**Town of Hamburg  
Planning Board Minutes  
4-25-90**

**Rezoning Petition of William C. Downey for Construction of a Convenience Food Mart - Southwestern Blvd. near Amsdell Rd.**

# SURVEY OF LOT NO - 26 25

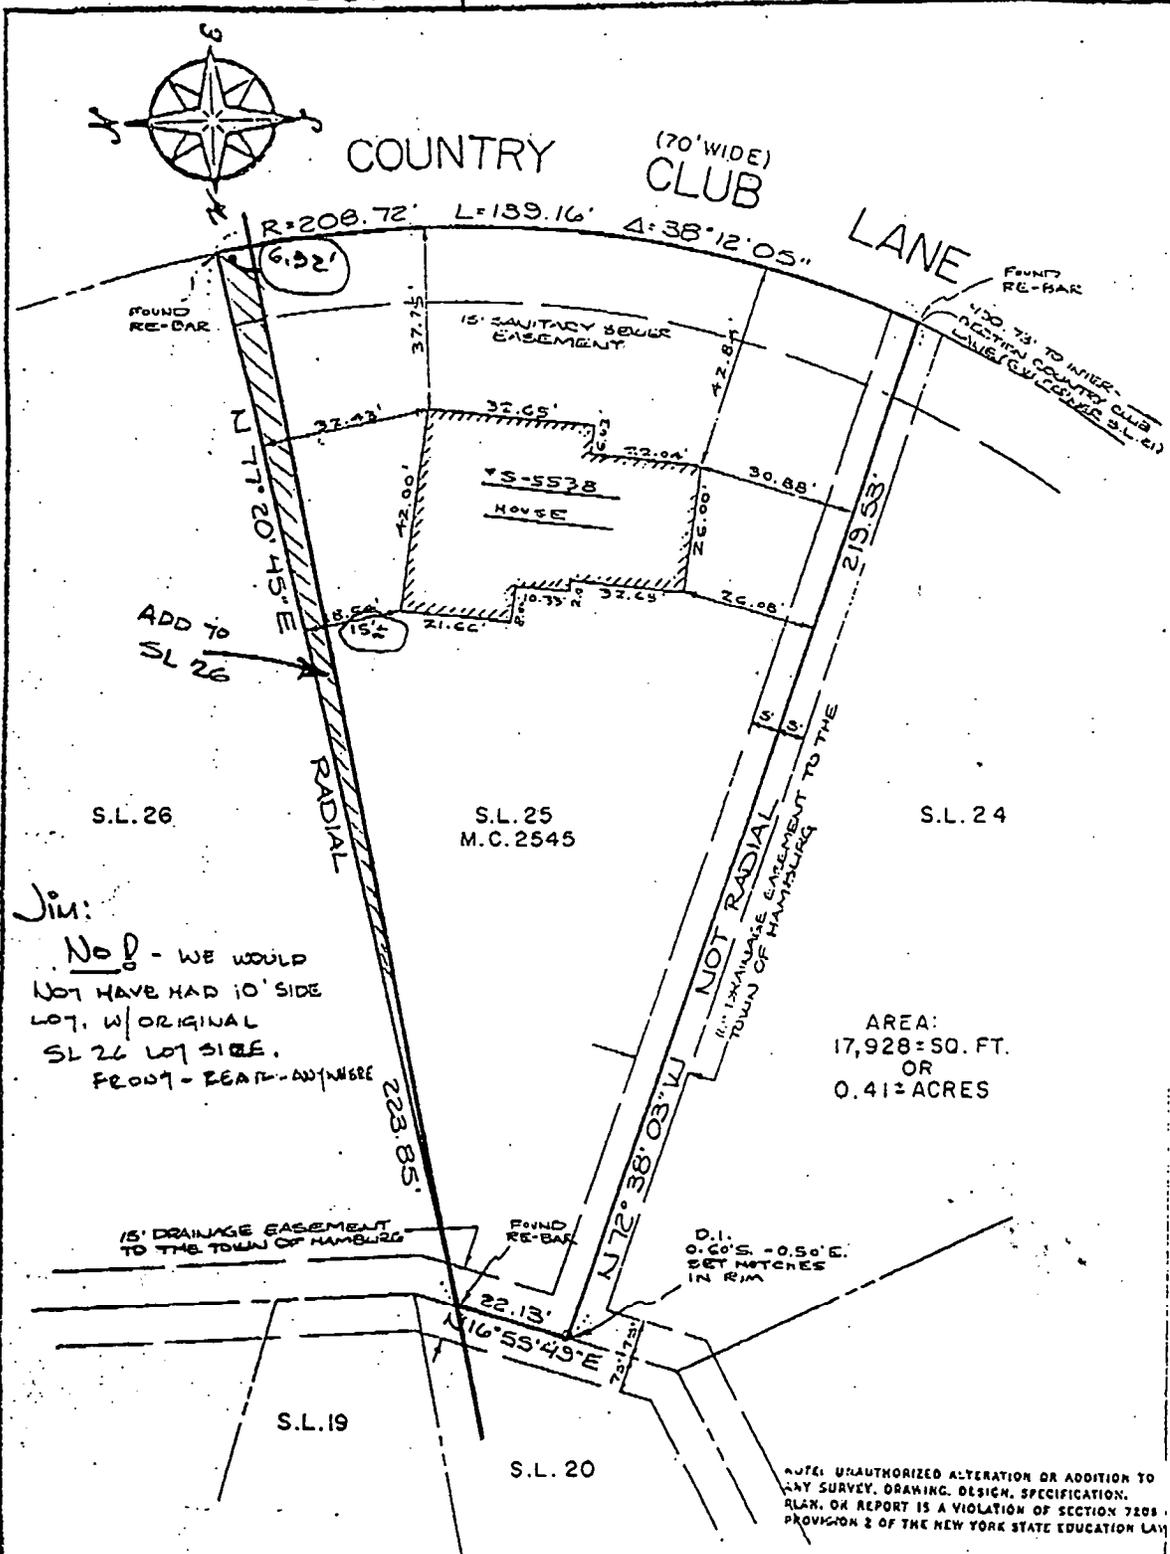
Jim:  
 No D - WE WOULD NOT HAVE HAD 10' SIDE LOT. W/ ORIGINAL SL 26 LOT SIDE. FRONT - BEAT IT ANYWHERE

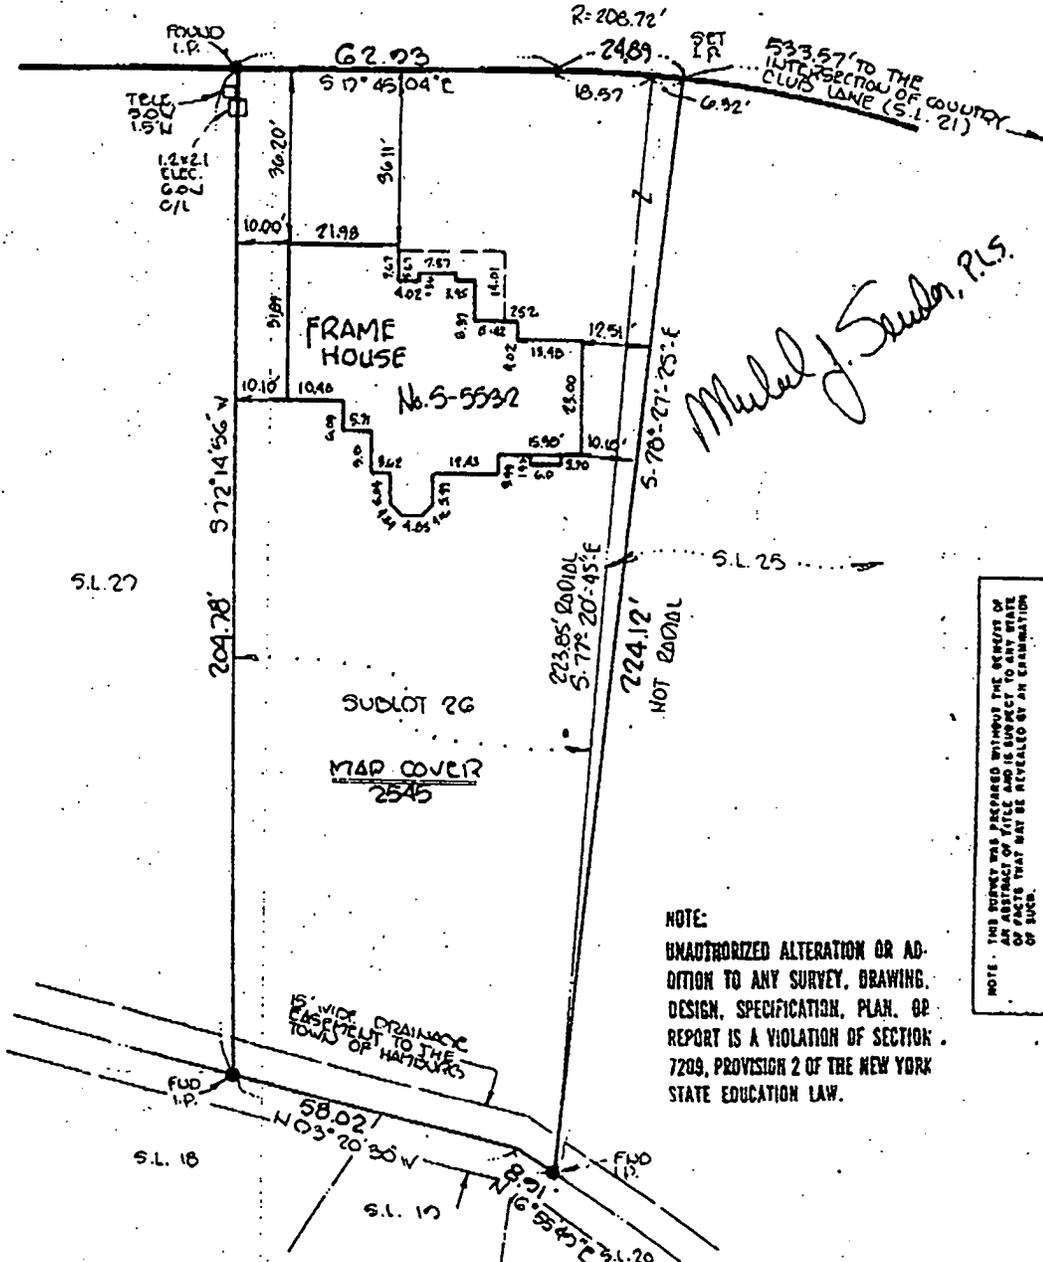
Eight (8) feet from subplot 25 of the filed map cover is to be deeded to subplot 26.

We feel the Z.B.O. should address this type of situation because moving the subplot lines is a re-subdivision not unlike what John Bosse and Pat Eddy did in Lakeview. Moving of the subplot lines also creates a pile of paper work for the County Real Property Division and our Assessors. We understand this was done a few times in Brierwood.
